Subject: **Woodland Glen Variance Request**
Duffy Street Horizontal Curvature and Posted Speed Limit Deviation

Subject: **Woodland Glen Variance Request - Full Warp Pavement Section Deviation**

Subject: Woodland Glen Variance Request – Right of Way Width Deviation

Subject: Woodland Glen Variance Request – Road Grade Deviation

APPROVED BY	REVISED DATE	CITY OF CENTRALIA
		MODIFIED ROADWAY SECTION
CITY ENGINEER	02/2024	50FT WIDE LOCAL ACCESS

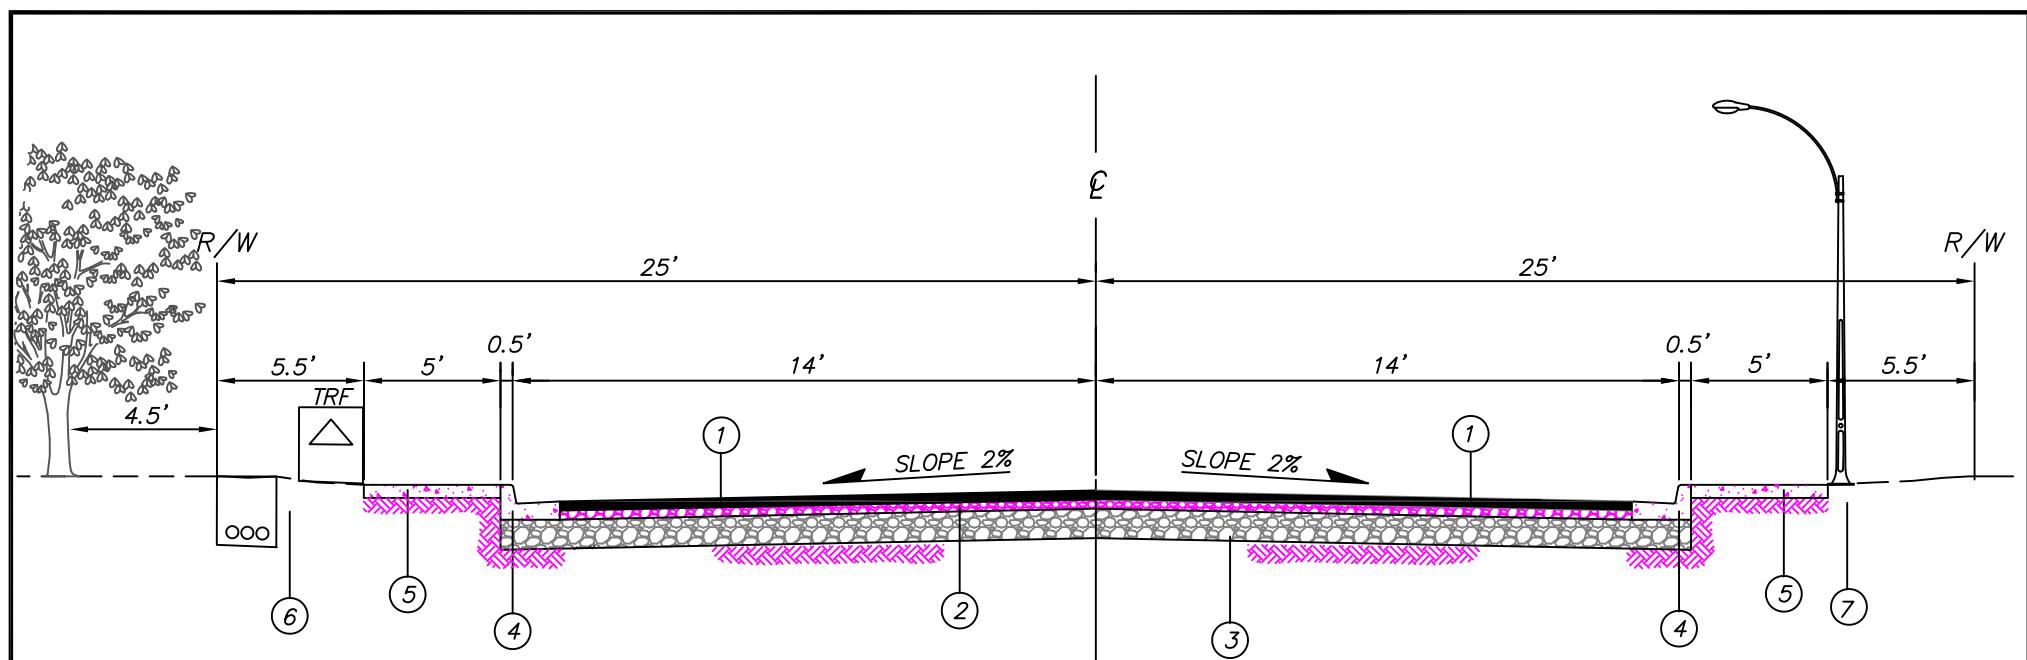
The proposed roadway cross section provides a four foot wide planter strip between the curb and sidewalk, which does not provide a wide planter strip for mature trees and utilities or additional separation for pedestrians. However, I believe a 50ft wide right of way width would be acceptable with the following conditions:

1. The sidewalk be installed adjacent to the curb per City Standards and all driveways be constructed in accordance with Standard Detail 5-03B.
2. The area in the right of way behind the sidewalk be reserved for utilities, with street light standards, water meter boxes, junction boxes and transformers being installed adjacent to the sidewalk and all conduit for electrical utilities be installed on the property side of those utility structures within the right of way.

3. Trees shall be planted on private property, a minimum of 9.5 feet from the back of the sidewalk. No trees shall be planted within the right of way. However, shrubs or vegetation shorter than 4ft tall would be acceptable where underground utilities are not located.
4. Mailboxes shall be provided in cluster neighborhood boxes and not individually at each lot.

I recommend approval of this deviation request for roads B, D, E, F and G with the modifications noted above and in accordance with the attached modified roadway section.
